Addendum No. 1
February 23, 2023

FHS – SHOSHONE,
IDAHO

The following items contain additions, deletions, or modifications to the Plans and Specifications. This Addendum forms a part of the Contract Documents and shall be bound inside the cover of the Project Manual.

FOOTING AND FOUNDATION PLAN
 SCALE: 3/16" = 1'-0"

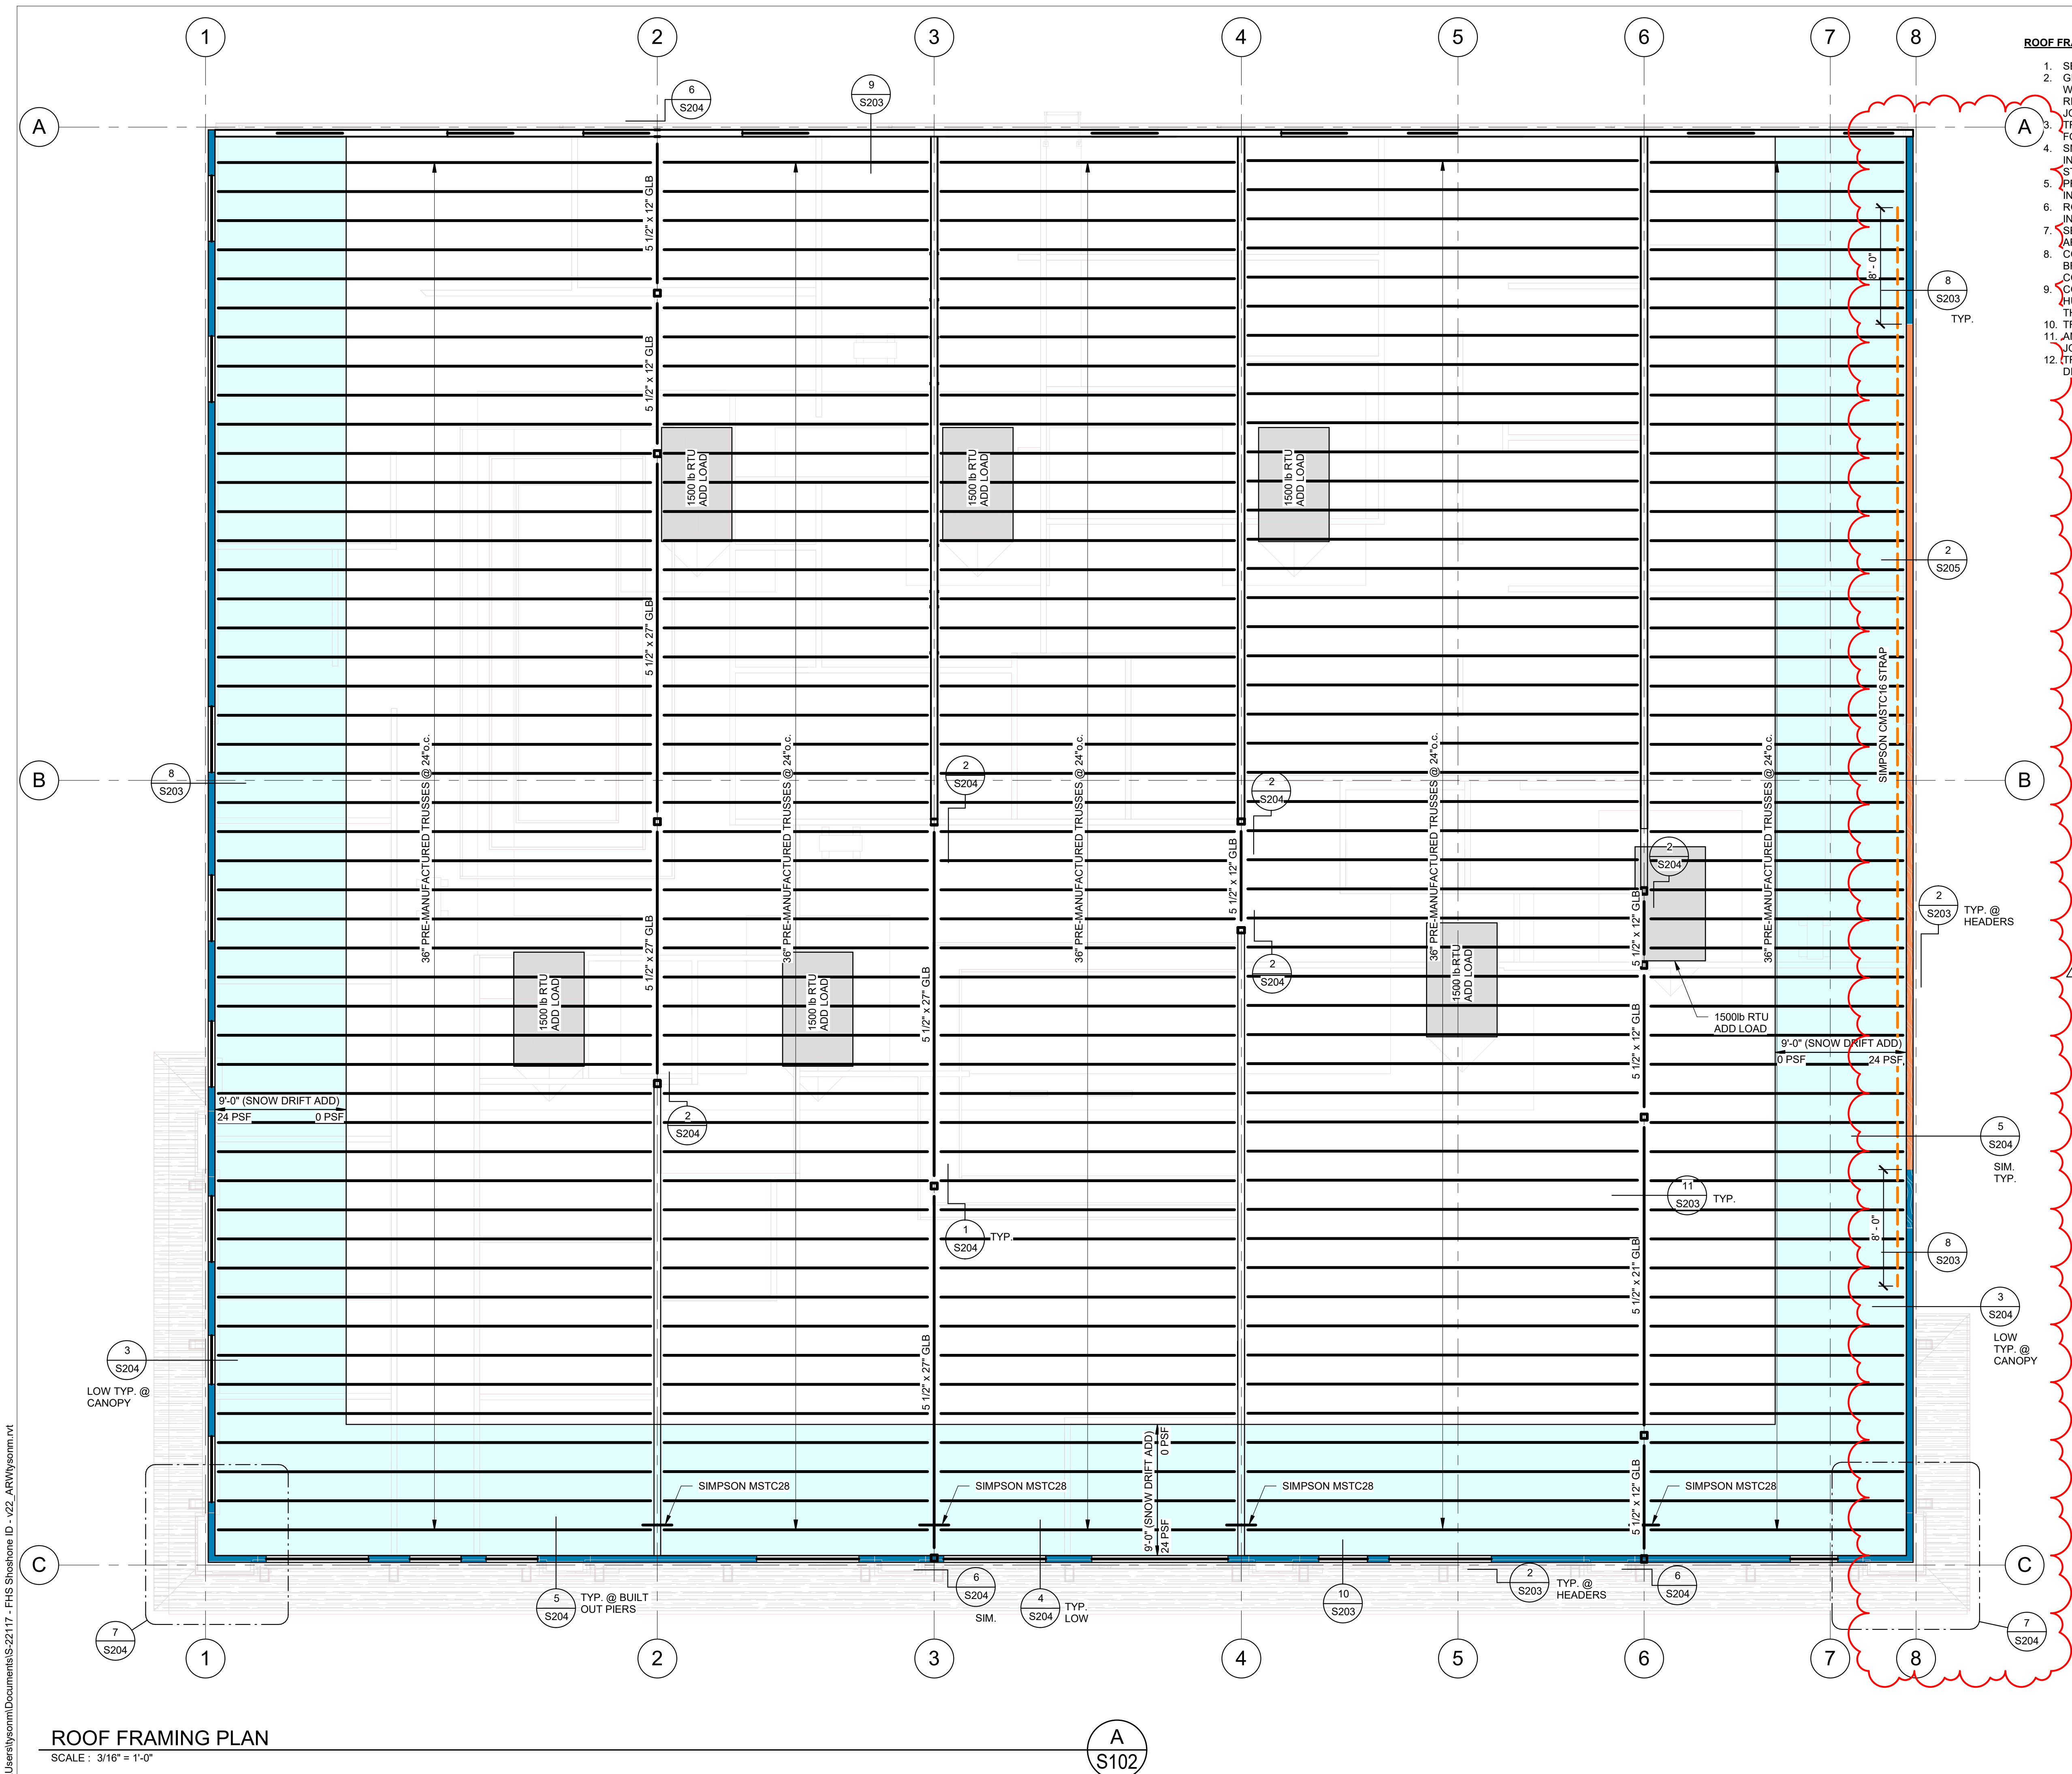
Sheet S101 revised per attached
Sheet S102 revised per attached
Sheet S204 revised per attached
Sheet S205 revised per attached
